Applicants request a Special Exception under Section 2.16.050 K (Carport over a Driveway) in an R-3 (Residential) zone.

This would permit a 15' by 20' carport that is proposed to encroach into the front yard setback and to be located to within 5' feet of the front property line.

ADDRESS SITE: 10181 SAIGON
NEW CARPORT ADDITION

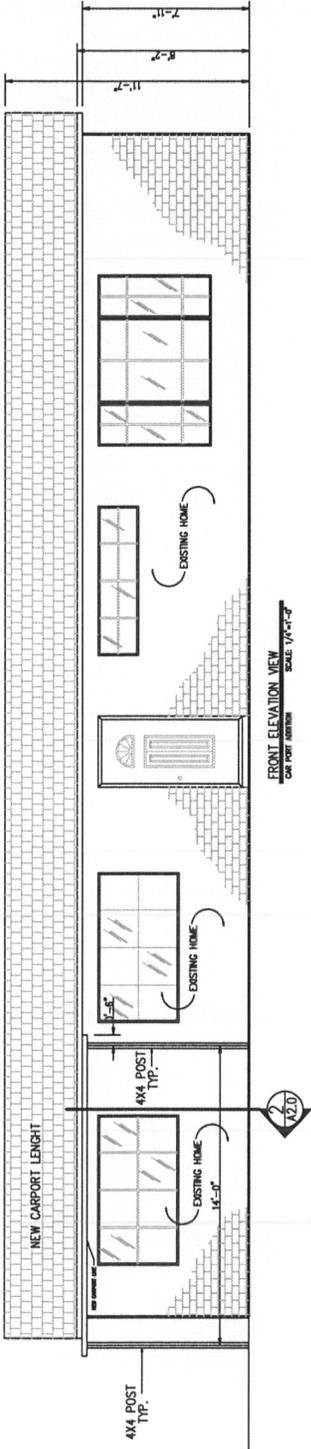
A site visit shows a shed located less than 5 feet from the main structure and located in the side setback. The applicant provided a survey that shows that the structure was there when she purchased the house. The applicant has been requested to provide a revised site plan.

Requested area of carport = 300 sq. ft. (15' x 30')

Requested front yard setback = 5'

Staff recommendation is pending submittal of a revised site plan and a written recommendation from Engineering & Construction Management.
